UNITED STATES PATENT AND TRADEMARK OFFICE

APPLICATION NO.	FILING DATE	FIRST NAMED INVENTOR	ATTORNEY DOCKET NO.	CONFIRMATION NO.
09/748,277	12/27/2000	Jae-Lag Ma	8733.363.00	4729

**Office Action Summary**

## DETAILED ACTION

FIG. 3

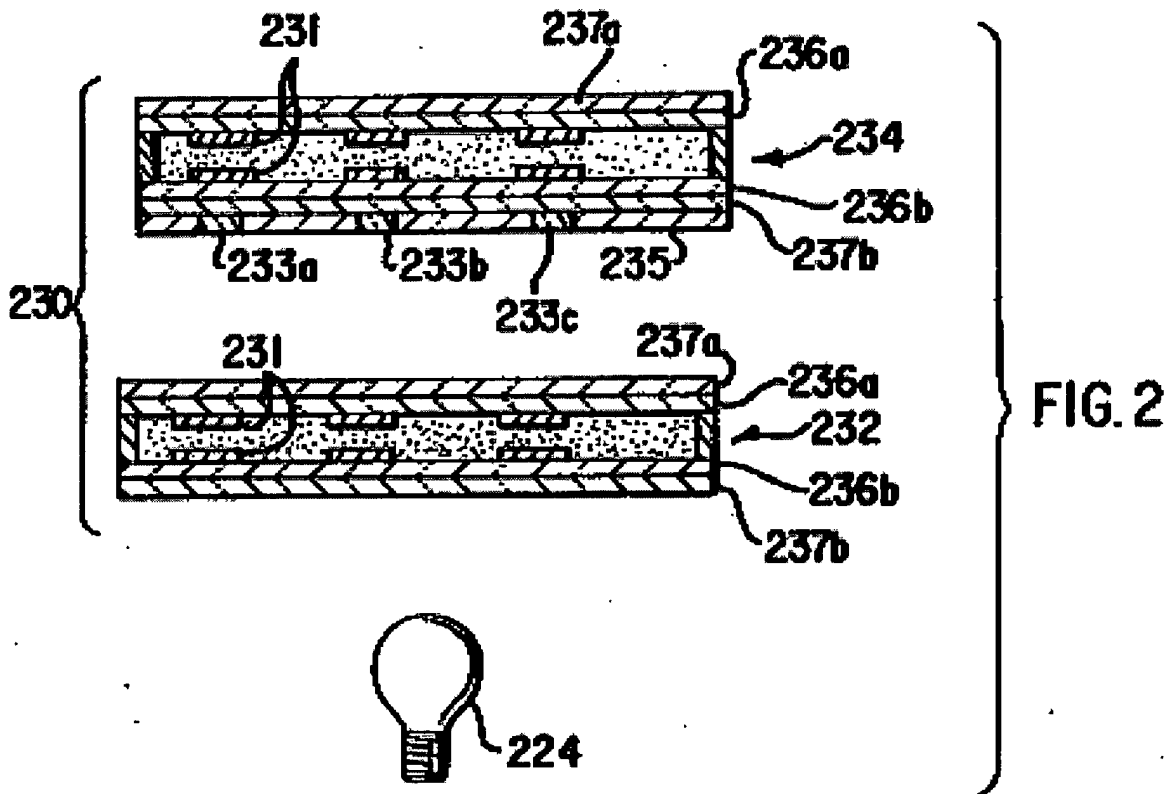
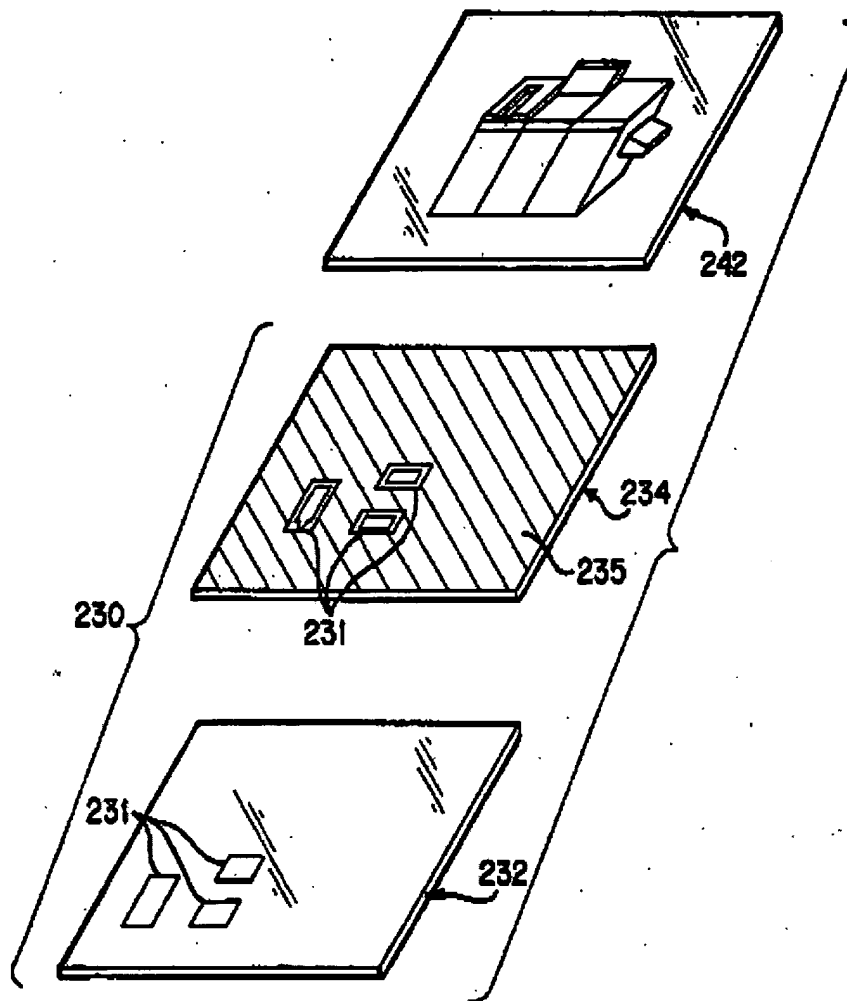
As to claims 1, 4, and 5, Dingwall teaches in Figures 2 and 3 (col. 5, lines 33-40 and col. 7, line 60 through col. 8 line 28), a liquid crystal display (LCD) device, comprising: an upper polarizer, 237a; an upper substrate under the upper polarizer, 236a; a liquid crystal layer under the upper substrate (between substrates); a lower substrate, 236b, under the liquid crystal layer; a lower polarizer, 237b, under the lower substrate, the lower polarizer including at least one opaque surround or black mask,

235, (Applicant's light shielding film) in a peripheral portion, formed in the four peripheral sides of the lower polarizer (as illustrated in Figure 3); and a backlight device, 224, positioned under the lower polarizer (see also Figure 4).

As to claims 2 and 3, Dingwall teaches (col. 8, lines 11-28) a liquid crystal display (LCD) device of claim 1, wherein the at least one opaque surround or black mask, 235, (Applicant's light shielding film) is formed by a photographic process, by offset lithography (Applicant's coating), or by screen printing (Applicant's printing) black mask materials that absorb the light (col. 8, lines 29-33).
